PLANNING, ZONING, & BUILDING DEPARTMENT
PZ&B Staff Memorandum: Landmarks Preservation Commission

SUBJECT: HSB-24-001 311 PENDELTON LANE

MEETING: JANUARY 17, 2024

HSB-24-001 311 PENDELTON LN. The applicant, Starr Haymes Kempin for Pendleton Lane Trust has filed an application requesting a Certificate of Appropriateness review and approval for a modified front entry, addition of shutters, relocation of a few windows in addition to hardscape modifications changing the driveway and reducing the paver pool deck to an existing two-story historically significant building.

Front elevation changes

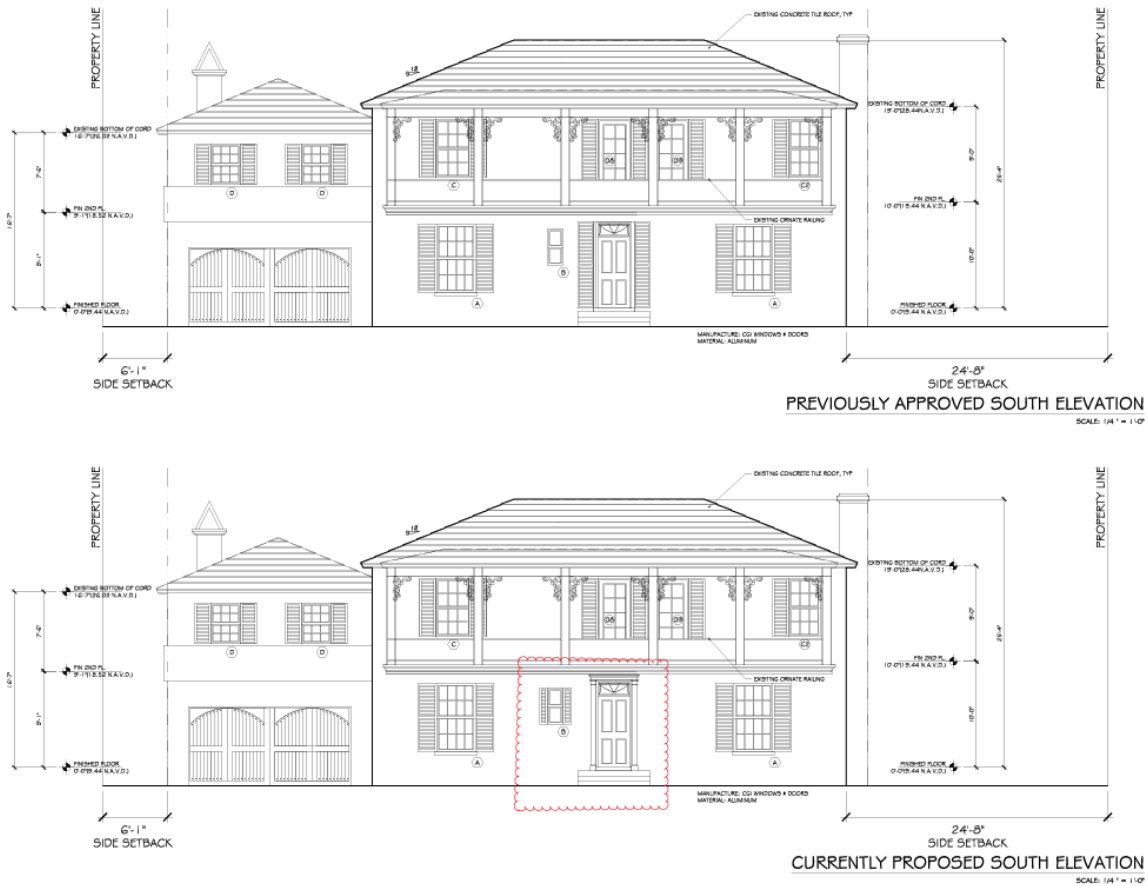
As an HSB project, the proposed changes must comply with the Secretary of the Interior's Standards for Rehabilitation and Sec. 18-306, Sec. 54-122 and 54-123 of the Landmark Preservation Ordinance. Most of the requested changes are minor, removable or site related. However, the modification of the front door to have applied pilasters in place of the original application of flanking full length shutters is inconsistent with the Secretary of the Interior's Standards. The other most visibly obvious proposed modification is the driveway layout from a straight driveway to a circular drive utilizing Chattahoochee gravel as the primary material.
